Access Compliance Report Public Rights-of-Way (Curb Ramps)

Intersection ID: 12646 Main Street: LEVINE_AVENUE_OF_THE_ARTSoss Street: S_TRYON_ST Location: W

ADA ID: CF0CCB2F2168 Ramp Type: Perp Initial Pass/Fail: Fail Overall Compliance: No Severity Score: 12.5

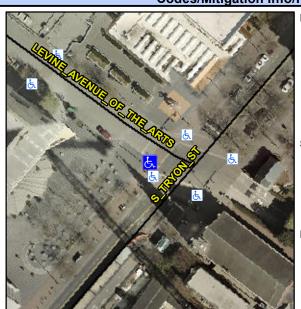
PROW/ADA:
R304.2.2

Field Measurements/Component Compliance							
Comp	Compliance Description		Comp	oliance Description	Data		
N/A	Ramp Length (in)	60.0	No	Ramp Slope (%)	10.4		
Yes	Ramp Width (in)	60.0	Yes	Ramp XSlope (%)	0.4		
N/A	Flare Type LT	N/A	N/A	Flare Type RT	N/A		
N/A	Flare Slope LT (%)	N/A	N/A	Flare Slope RT (%)	N/A		
N/A	Flare Traversable LT?	N/A	N/A	Flare Traversable RT?	N/A		
N/A	Landing Length (in)	N/A	N/A	DWS Provided?	N/A		
N/A	Landing Width (in)	N/A	N/A	DWS Contrast?	N/A		
N/A	Landing Slope (%)	N/A	N/A	DWS Length (in)	N/A		
N/A	Landing X Slope (%)	N/A	N/A	DWS Full Width?	N/A		
N/A	Landing Curb? (Y/N)	N/A	N/A	DWS Offset (in)	N/A		
N/A	Shared Landing?	N/A					
N/A	Gutter Ponding?	N/A	N/A	Gutter Slope (%)	N/A		
N/A	Gutter Lip Ht (in)	N/A	N/A	Gutter X Slope (%)	N/A		
N/A	Painted X Walk1?	Yes	N/A	Painted X Walk2?	N/A		
	X Walk 1 Direction	To NE		X Walk 2 Direction	N/A		
N/A	X Walk 1 Width (in)	139.0	N/A	X Walk 2 Width (in)	N/A

Possible Solutions:
Remove & Replace Entire Ramp.
